WESTWIND SERVICE CENTER NEWSLETTER

January, 1987

This month's **IPC corrections and additions** are as follows:

Figure 1. Position and Warning Instl (Page 2 of 4)

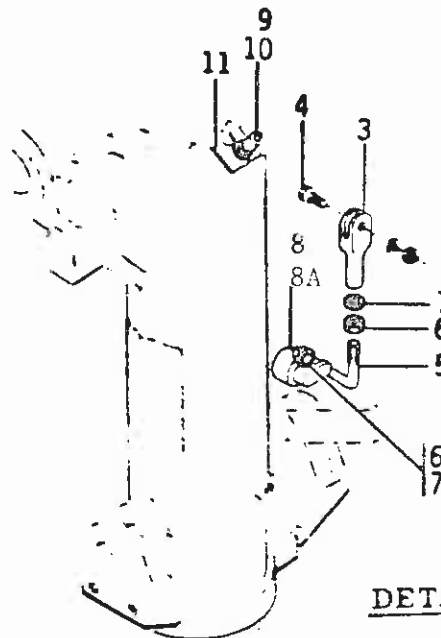
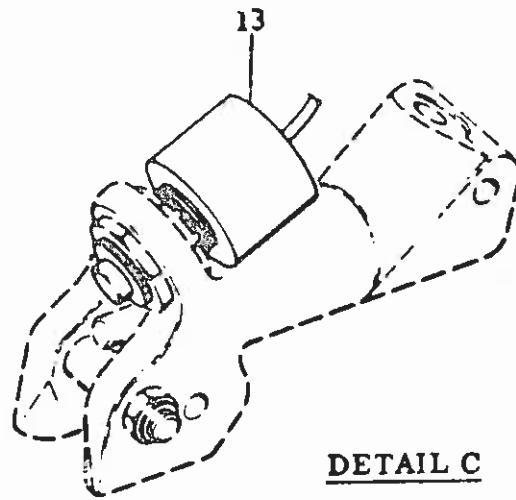
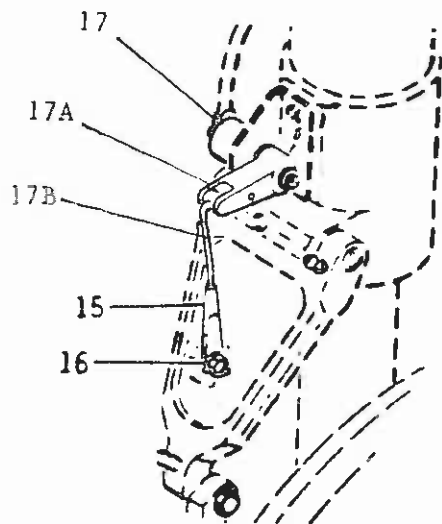
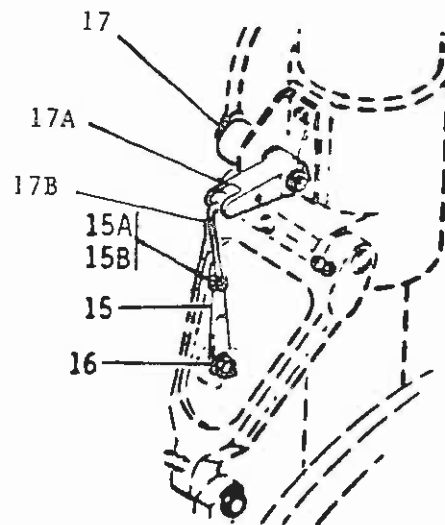
Special attention should be made to the 1124 IPC when ordering either the nose gear or the main gear **ground contact switches** and/or the adjustment bolts. On the nose, the bolt that is attached to the 6AP3 arm assembly is used (included with the replacement 444EN1-12 switch). On the main gear, this bolt is not used and should be discarded. Bolt part number 253507-1 is the proper bolt and will not be included with the 444EN1-12. This bolt must be ordered separately. Note also, that the 6AP3 arm assembly can be purchased individually. The corrected IPC pages are attached.

AN960D10	..WASHER (AP)		001
17	444EN1-12	..SWITCH (INCLUDES ITEM 17A FOR SPARES)		001
17A	6PA3	...ARM- (INCLUDES THREADED BOLT)		001
17B	NO NUMBER	...BOLT, THREADED (INCLUDED IN ITEM 17A)		001
18	4 B23012-501	.SWITCH ASSY, DOWNLOCK, NOSE GEAR		001
19	4 B23012-15	..ANGLE		001
20	AN3H30A	..BOLT (AP)		001
21	AN3H3A	..BOLT (AP)		001
	AN960-D10L	..WASHER (AP)		001
22	4 B23012-13	..RETAINER		001
23	AN3H3A	..BOLT (AP)		001
24	4 B23012-17	..ANGLE		001
24A	4 B23019-19	..ANGLE	187306	001
25	AN509-10R7	..SCREW (AP)	307999	001
26	402EN1-12	..SWITCH (V. 91929)		001
27	43DM1	.HORN, GEAR WARNING (V. 04211)		001
28	ANS15-BR8	..BOLT (AP)		003
	MS20365-832	..NUT (AP)		003
	AN960-DB	..WASHER (AP)		003
